Agenda Item # 6 SUB-002991-2024

Vivian’s Homes Subdivision

- Subdivision approval to create four (4) legal lots of record from two (2) existing metes-and-bounds parcels.

APPLICATION NUMBER 6 DATE July 18, 2024

DETAIL SITE PLAN

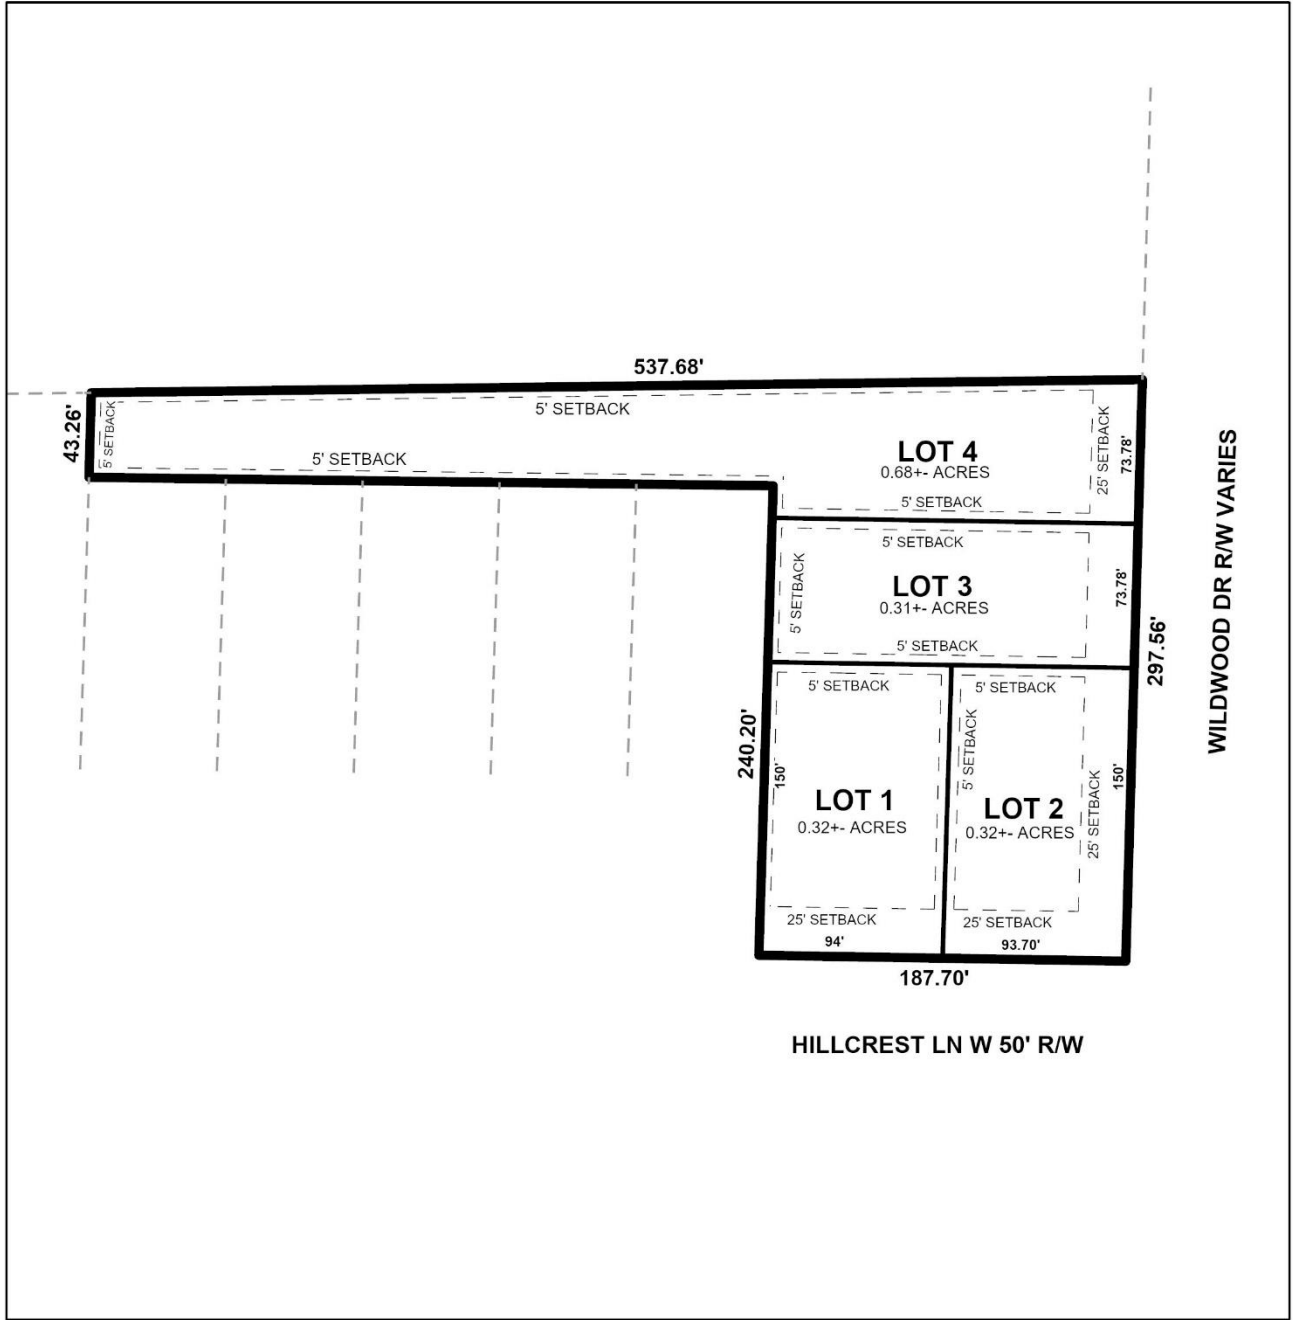
- B. Revise the spelling of “COMER” in the written legal description to “CORNER”.
- C. Review and revise the plan and the written legal description to correct the discrepancy between Wildwood Roosevelt Avenue and Roosevelt Street.

- D. Review and revise the plan and the written legal description to correct the discrepancy between Hillcrest Ln. W. and Pansy Lane.
- E. Dedicate the corner radius (25’ minimum or as approved by the City Engineer and Traffic Engineer) at the southeast corner of LOT 2 to the City of Mobile, and list the amount of dedicated acreage (square feet and acre).

- F. Add a note to the SUBDIVISION PLAT stating that as shown on the 1984 aerial photo (#23/78) LOTS 1, 2, 3, and 4 will receive historical credit of existing (1984) impervious area towards stormwater detention requirement per Mobile City Code, Chapter 17, Storm Water Management and Flood Control) as follows: LOT 1 – 1,300 sf, LOT 2 – 1,000 sf, LOT 3 – 2,900 sf, and LOT 4 – 1,800 sf.

The site has frontage on Hillcrest Lane West and Wildwood Drive, both minor streets. Hillcrest Lane West has curb and gutter with a compliant 50-foot right-of-way; therefore, no dedication would be required along the Hillcrest Lane West frontage. If approved, the right-of-way width of Hillcrest Lane West should be retained on the Final Plat. Wildwood Drive does not have curb and gutter and would require a 60-foot right-of-way. However, the Pace Subdivision and Hillcrest Lane Subdivision, both from 1985, only required a 50-foot right-of-way. Thus, dedication to provide 25 feet from the centerline of Wildwood Lane should be required if the right-of-way is less than 50 feet. If approved, the plat should be revised to indicate the right-of-way width of Wildwood Lane after any required dedication. A 25-foot radius curve should be dedicated at the intersection of Hillcrest Lane West and Wildwood Lane per Section 6.C.6 of the Subdivision Regulations.

The preliminary plat indicates a 25-foot minimum building setback line along both street frontages, and this should be retained on the Final Plat, if approved, adjusted for any required dedication. If approved, the plat should be revised to remove the 5-foot side yard and rear yard setback lines. The lot size labels in both square feet and acres should be retained on the Final Plat, if approved, adjusted for any required dedication, or a table should be furnished on the Final Plat providing the same information.

As proposed, Lot 4 would exceed the depth-to width ratio of Section 6.C.3. of the Subdivision Regulations and would require a waiver of that section, if approved.

1. Retention of the right-of-way width of Hillcrest Lane West on the Final Plat;
2. Dedication to provide 25 feet from the centerline of Wildwood Drive, if the existing right-of-way is less than 50 feet;

3. Revision of the plat to label the minimum right-of-way width of Wildwood Drive after any required dedication;
4. Dedication to provide a 25-foot radius curve at the intersection of Hillcrest Lane West and Wildwood Drive;

5. Retention of the 25-foot minimum building setback line along both street frontages on the Final Plat, adjusted to be measured from any required dedication;

6. Revision of the plat to remove the 5-foot side yard and rear yard setback lines on the Final Plat;
7. Retention of the lot size labels in both square feet and acres on the Final Plat, adjusted for any required dedication, or the furnishing of a table on the Final Plat providing the same information;
